To: T10 Technical Committee  
From: Mahbubul Bari ([bari@vitesse.com](mailto:bari@vitesse.com))  
Subject: SAS-2 Return Loss Measurement Methodology

Return loss measurement methodology.

Figure B.13 — Four single-ended port or two differential port element

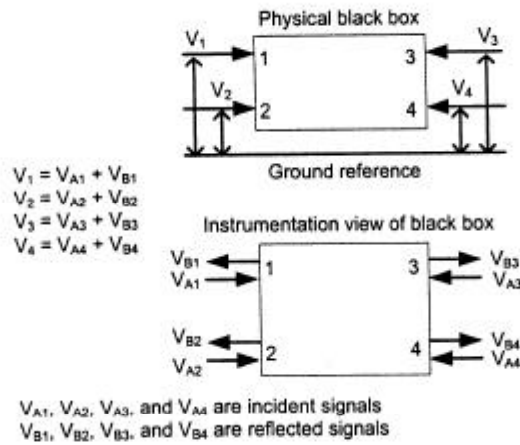
Section B.9 in Annex B describes S-parameter measurements. Clarification should be added to section B.9.3 on transmitter and receiver connection related to the S-parameter measurements. Will also include the derivation information from the Jenkins proposal.

VNA ports are all single-ended; the differential and common-mode properties for differential ports are calculated internal to the VNA or may mathematically derived. If using a TDNA, consult the details for the specific instrument. Four analyzer ports are required to measure the properties of two differential ports.

Figure B.14 — S-parameters for single-ended and differential systems

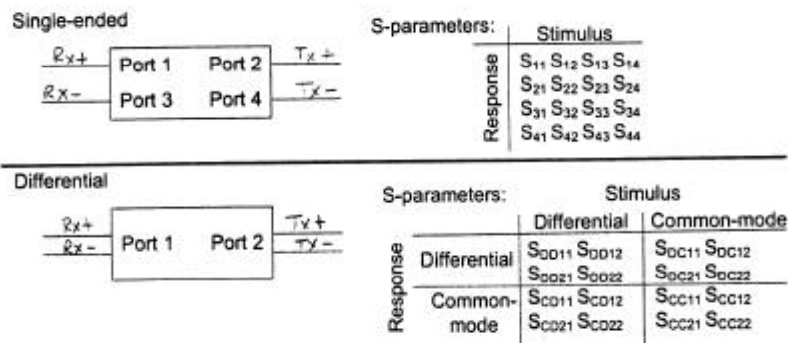
Figure B.14 shows the set of S-parameters for a single-ended system and for a differential system.
